TO: Mountain Village Design Review Board

RE: Staff Memo – Initial Architecture and Site Review (IASR) Lot SS811, 2 Mountain Village Boulevard pursuant to CDC Section 17.4.11

APPLICATION OVERVIEW: New Single-Family Home on Lot SS811

Grading with Driveway Profiles

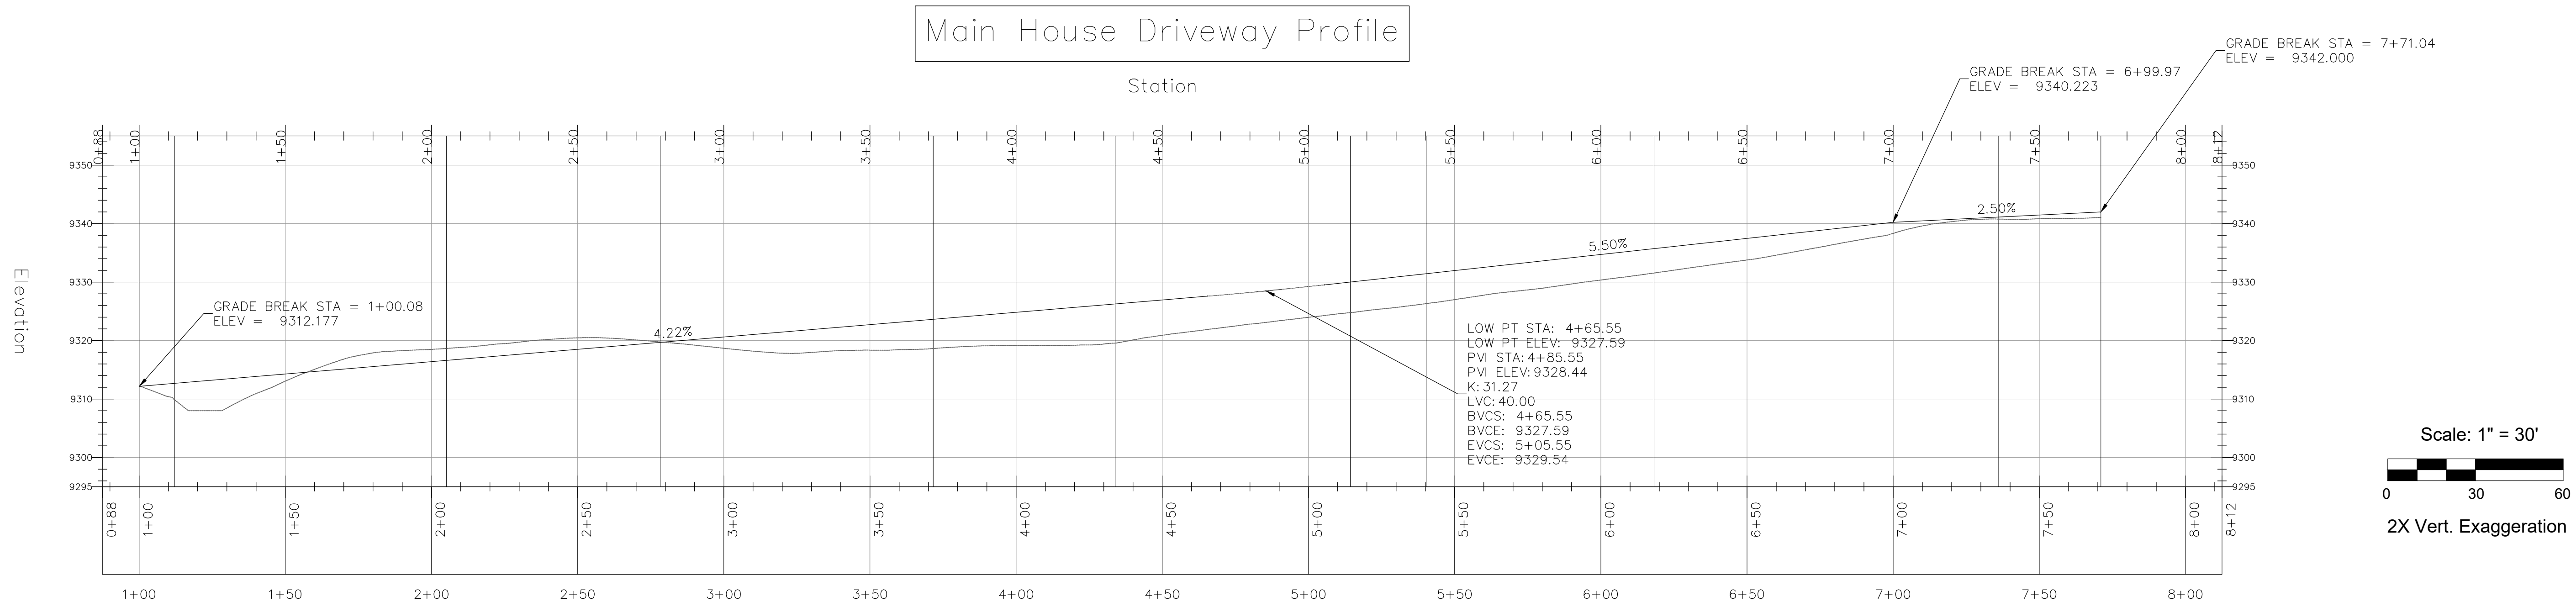
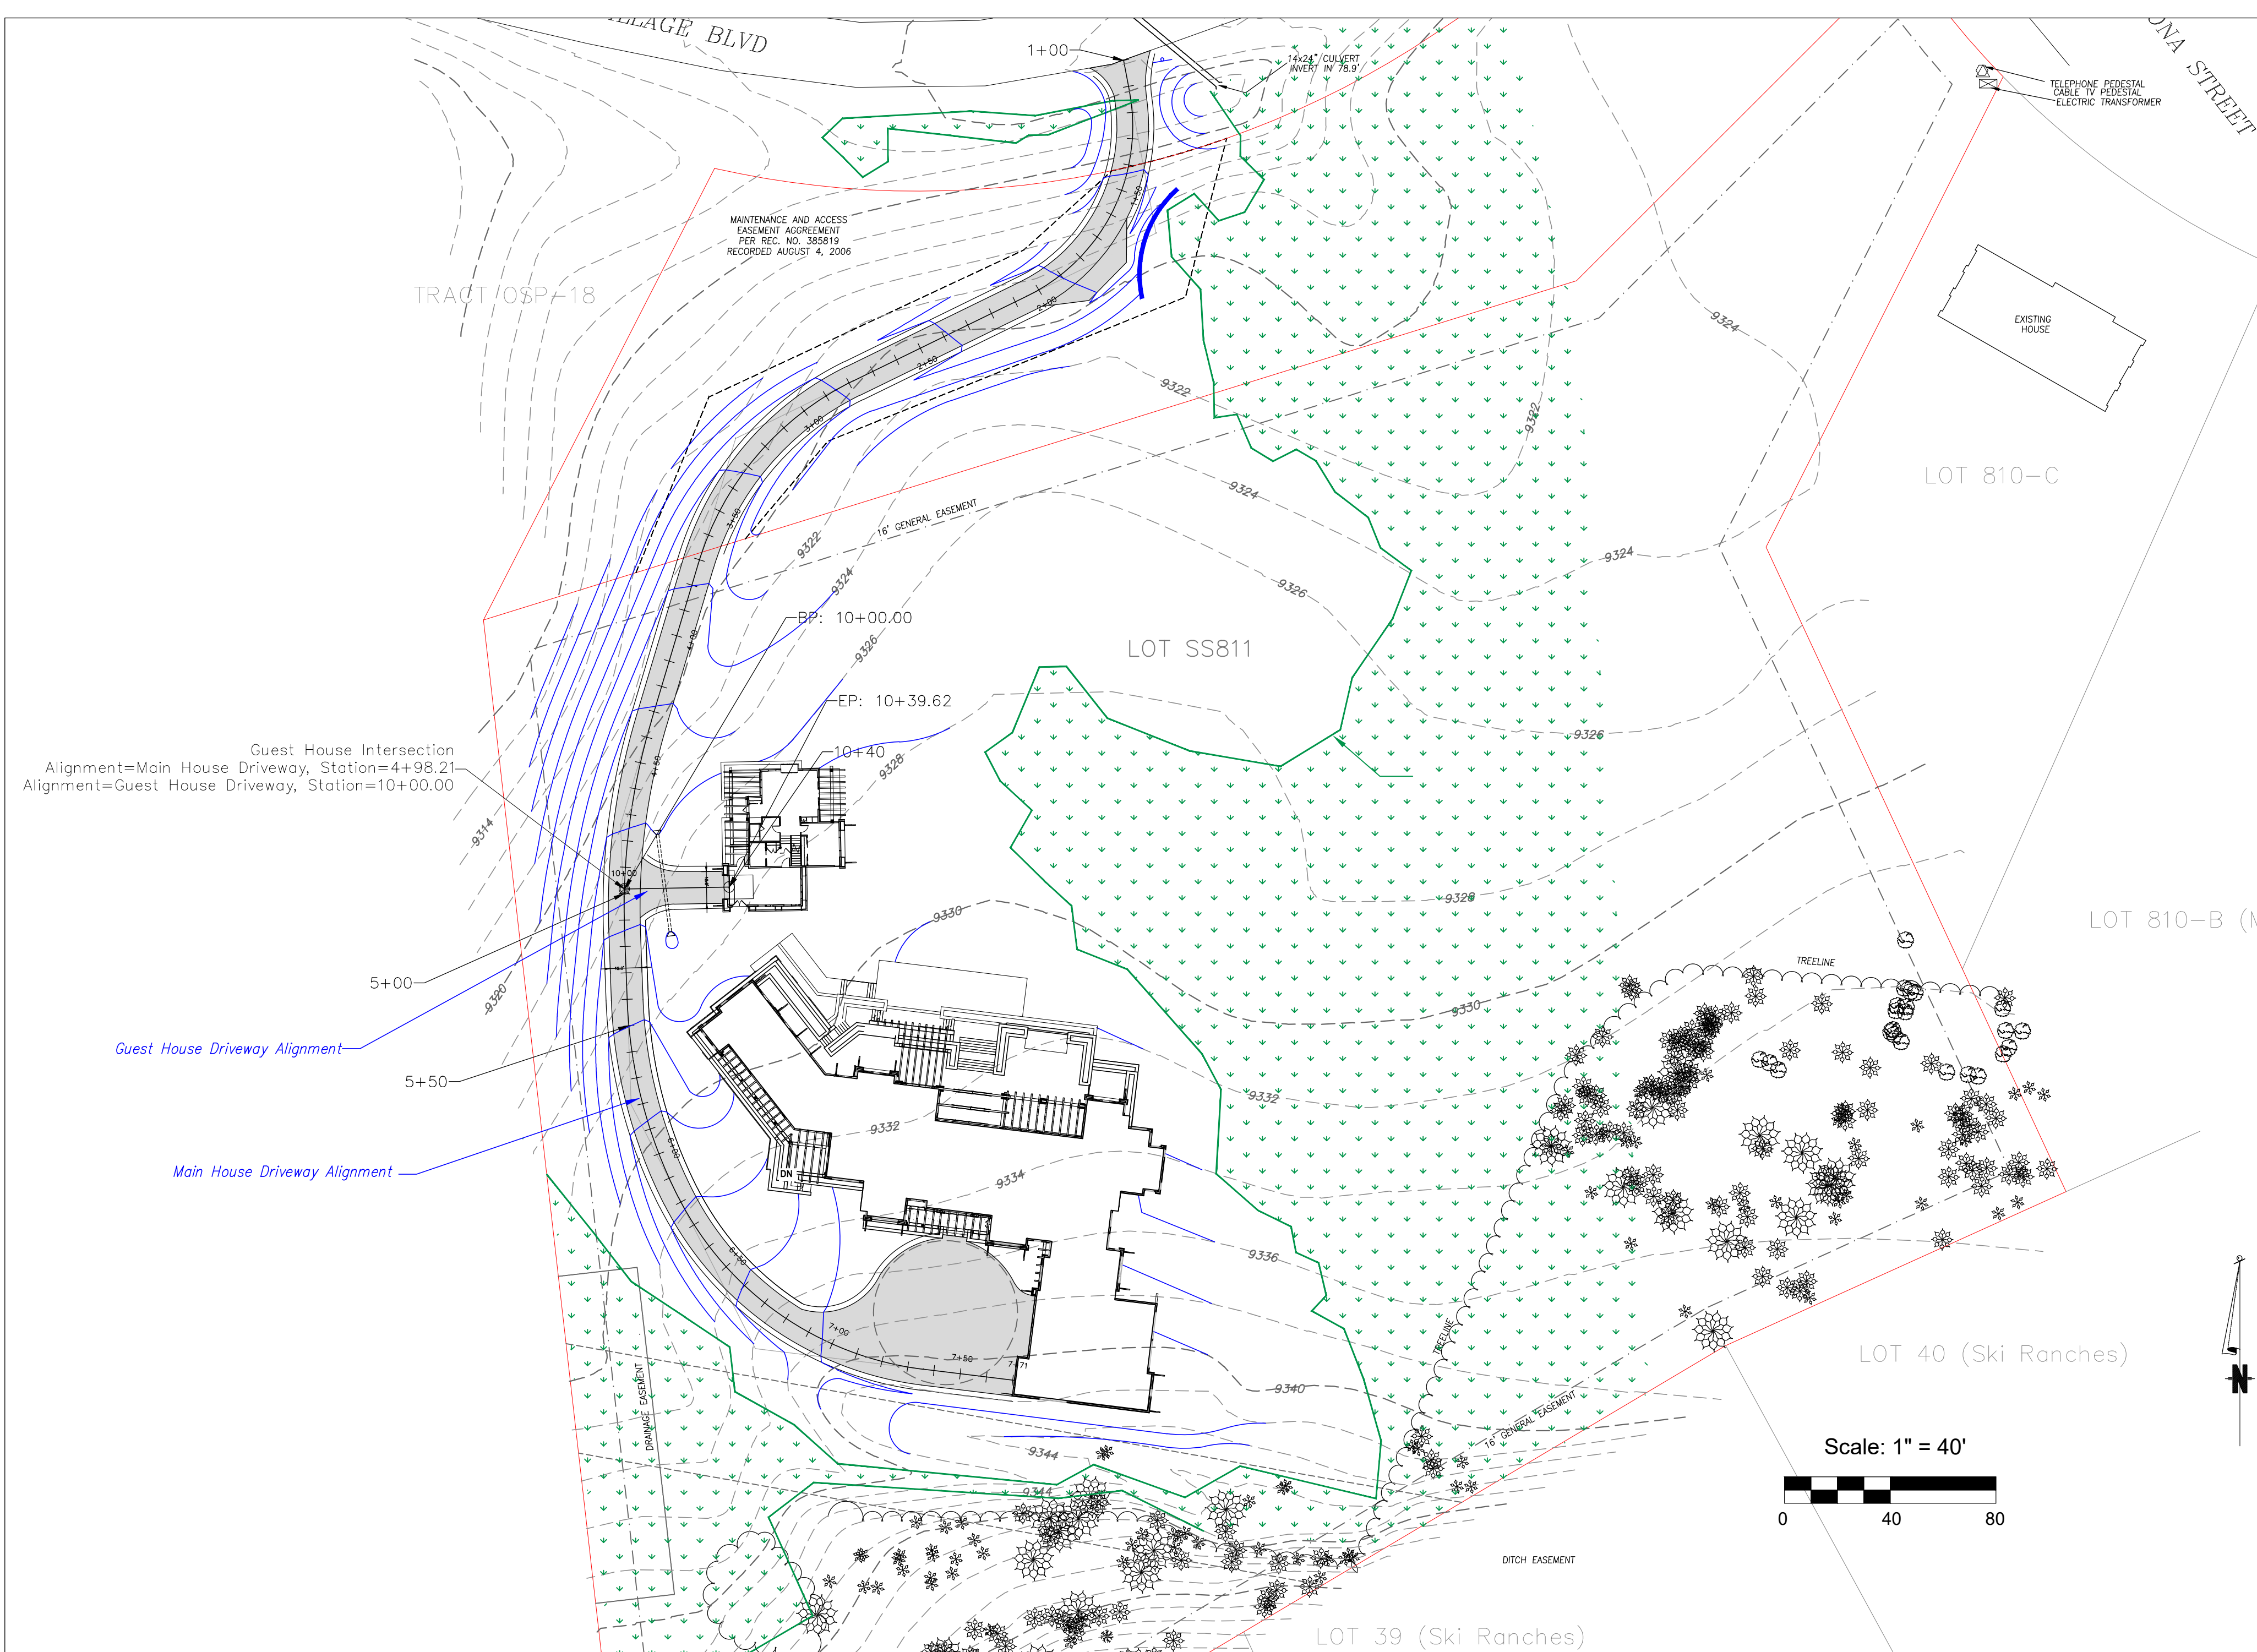
Staff: Sheet C2 of Exhibit A depicts the grading plan with information for the driveway grade. The driveway grade is within the maximum allowed grade of 8 percent with a maximum grade of 5.5 percent.

East Elevation Height

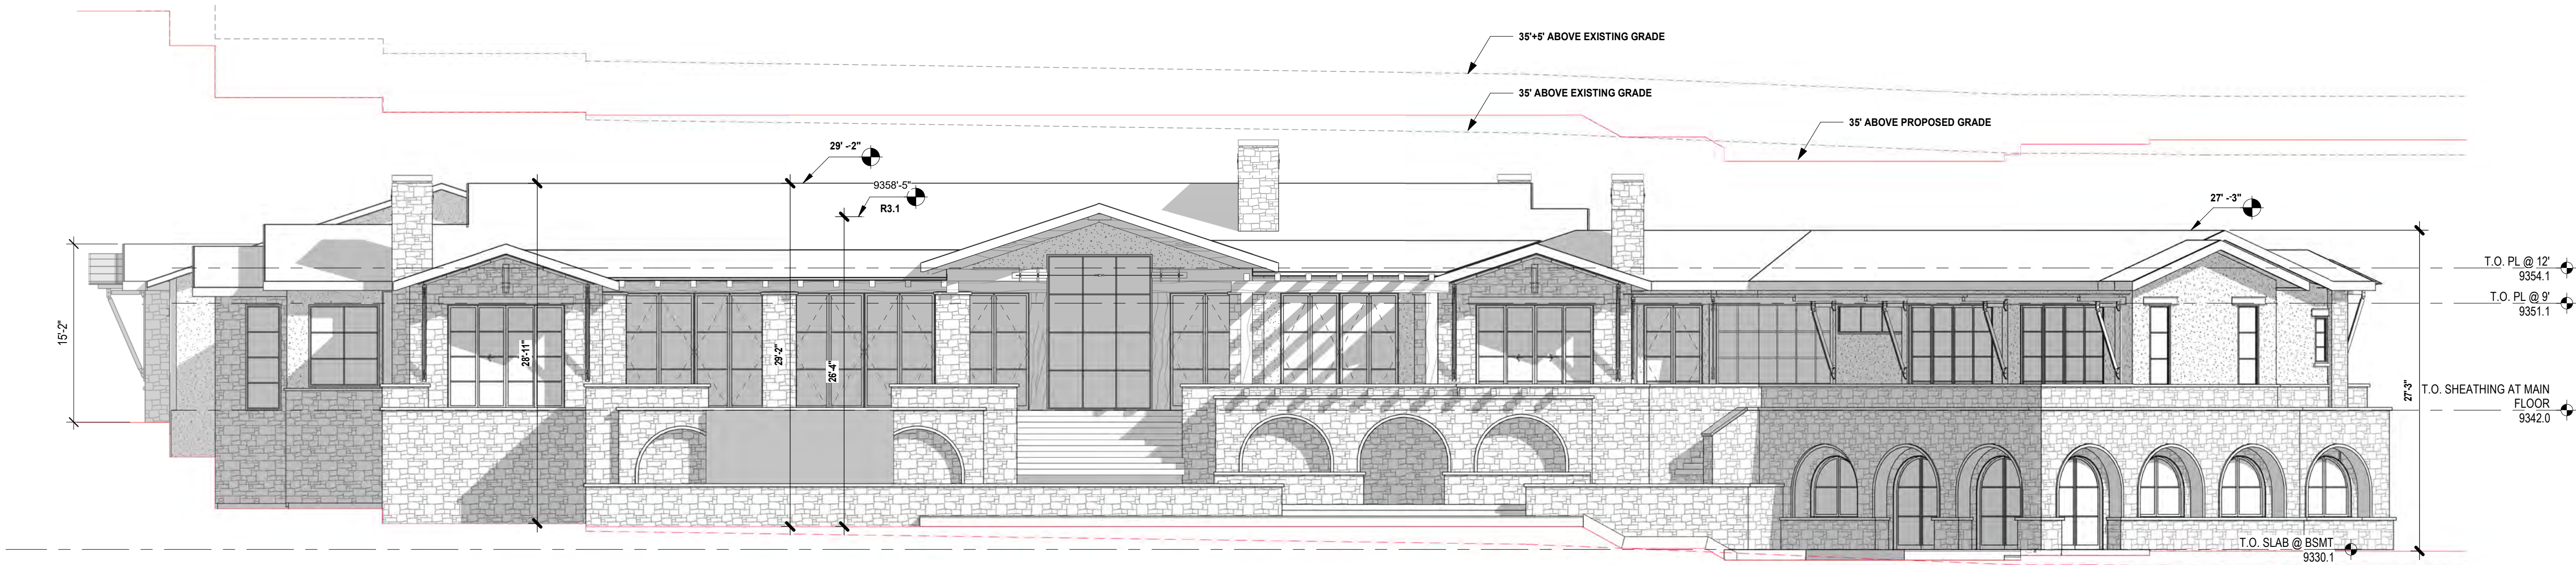
Sections 17.3.11 and 17.3.12 of the CDC provide the methods for measuring maximum building height and average building height, along with providing the height allowances for specific types of buildings based on their roof form. The proposed design incorporates a combination of gabled roof forms. Homes with a primary shed roof form are allowed a maximum building height of 40 feet. The average height is an average of measurements from a point halfway between the roof ridge and eave. The maximum height is measured from the highest point on a roof directly down to the existing grade or finished grade, whichever is more restrictive.

<p> BOX 2006 CAREFREE, AZ 85377 (480) 225-7282 JUSTIN@JK.STUDIO </p> <p> 05-07-2022 04:02:53 PM </p>	
<p style="font-weight: bold; font-size: 1.2em;">SHEET NO.</p> <p style="font-size: 2em; font-weight: bold;">A-6.1</p>

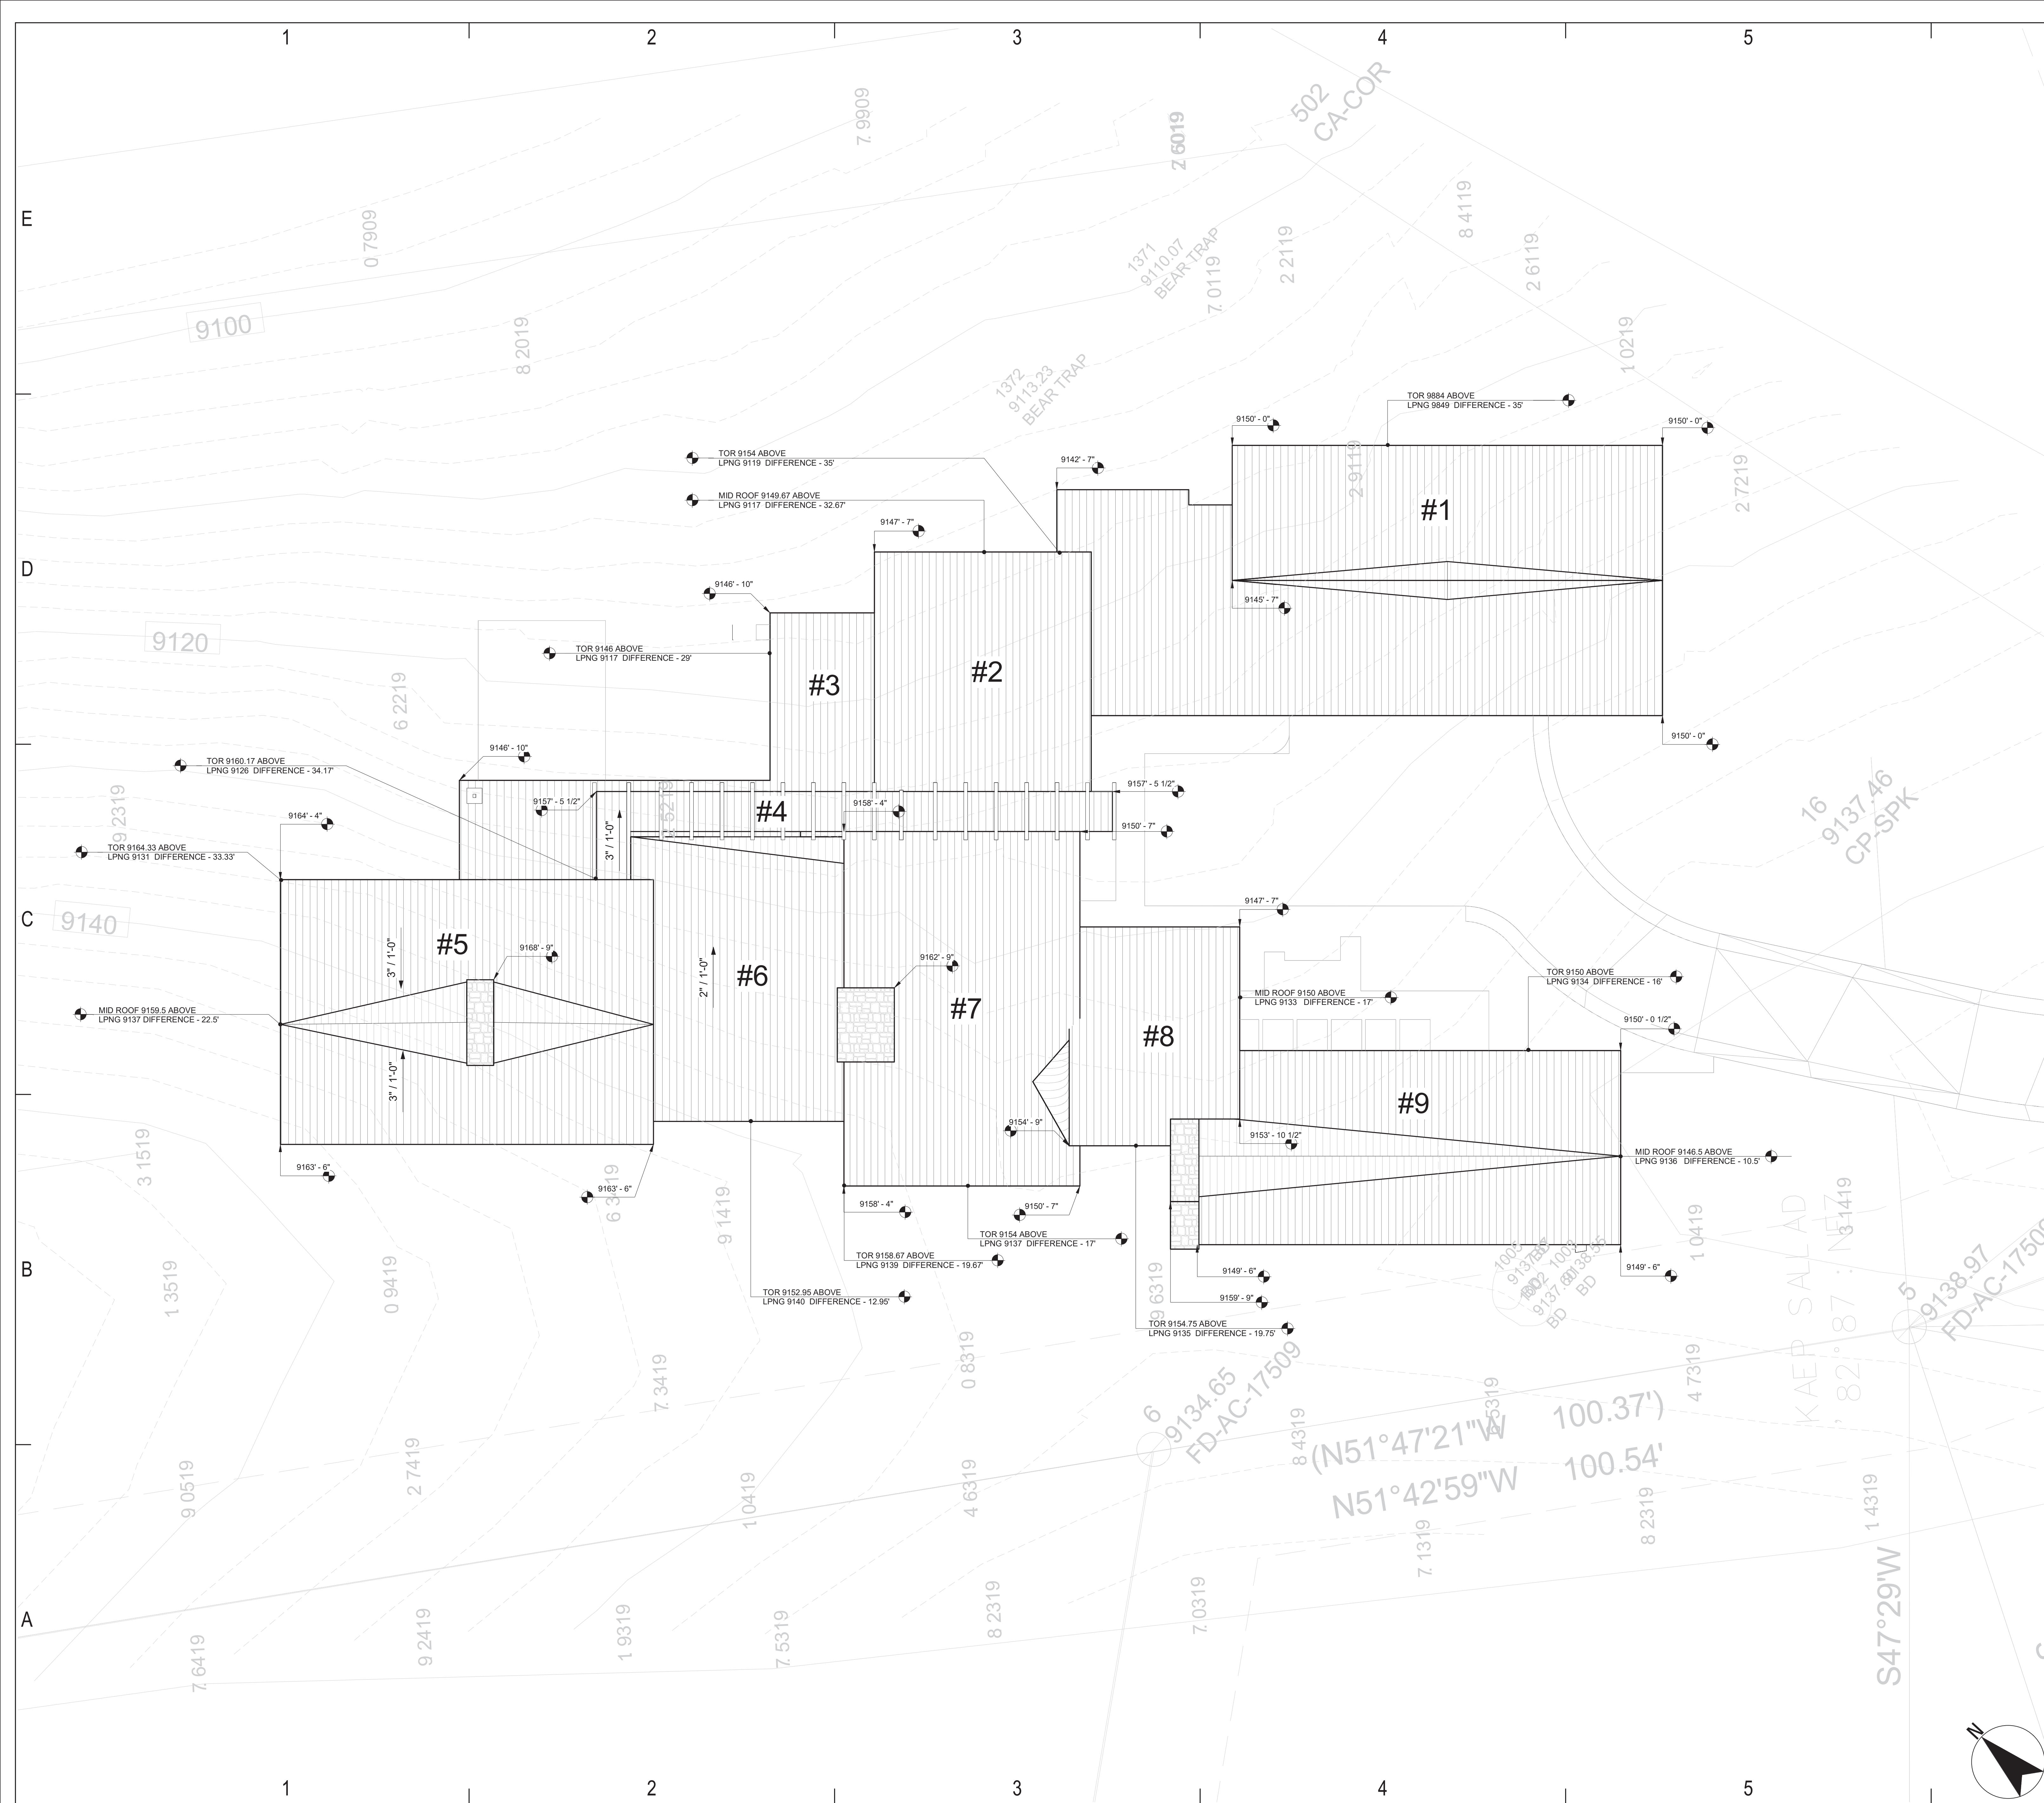
* The applicant has indicated 34.17' as the max height in the chart on Sheet A-6.2, however Sheet A-4.1 North Elevation shows a height of 38' 9 1/2"
